Access Compliance Report

Public Rights-of-Way

(Curb Ramps)

Intersection ID: 10021845	Main Street: BRIXHAM_HILL_AV	Cross Street: N/A	Location: N
ADA ID: 9AF0FF508720	Ramp Type: Perp	Initial Pass/Fail: Fail	Overall Compliance: No
Severity Score: 12.5			
Codes/Mitigation Info/Possible Solution		Field Measurements/Component Compliance

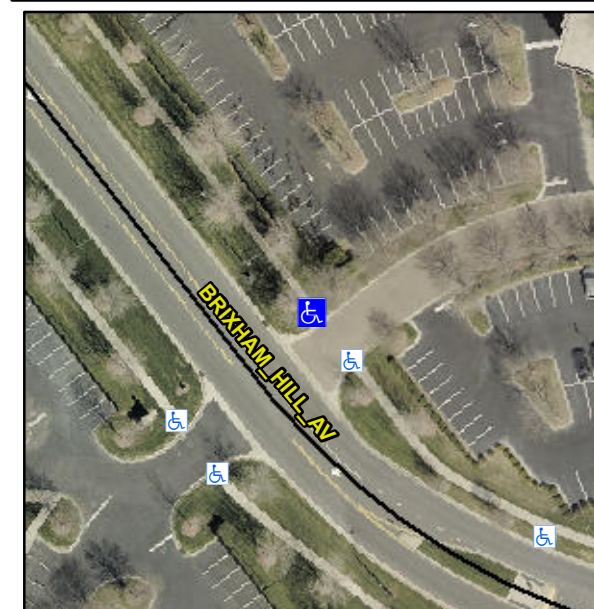
Not Found, R304.2.2

Compliance	Description	Data	Compliance	Description	Data
N/A	Ramp Length (in)	71.0	No	Ramp Slope (%)	9.1
Yes	Ramp Width (in)	58.0	Yes	Ramp XSlope (%)	0.8
N/A	Flare Type LT	N/A	N/A	Flare Type RT	N/A
N/A	Flare Slope LT (%)	N/A	N/A	Flare Slope RT (%)	N/A
N/A	Flare Traversable LT?	N/A	N/A	Flare Traversable RT?	N/A
N/A	Landing Length (in)	N/A	N/A	DWS Provided?	N/A
N/A	Landing Width (in)	N/A	N/A	DWS Contrast?	N/A
N/A	Landing Slope (%)	N/A	N/A	DWS Length (in)	N/A
N/A	Landing X Slope (%)	N/A	N/A	DWS Full Width?	N/A
N/A	Landing Curb? (Y/N)	N/A	N/A	DWS Offset (in)	N/A
N/A	Shared Landing?	N/A			
N/A	Gutter Ponding?	N/A	N/A	Gutter Slope (%)	N/A
N/A	Gutter Lip Ht (in)	N/A	N/A	Gutter X Slope (%)	N/A
N/A	Painted X Walk1?	No	N/A	Painted X Walk2?	N/A
	X Walk 1 Direction	To SE		X Walk 2 Direction	N/A
N/A	X Walk 1 Width (in)	N/A	N/A	X Walk 2 Width (in)	N/A
	X Walk 1 Slope (%)	0.9		X Walk 2 Slope (%)	N/A
	X Walk 1 X Slope (%)	4.6		X Walk 2 X Slope (%)	N/A

Remove & Replace Entire Ramp.
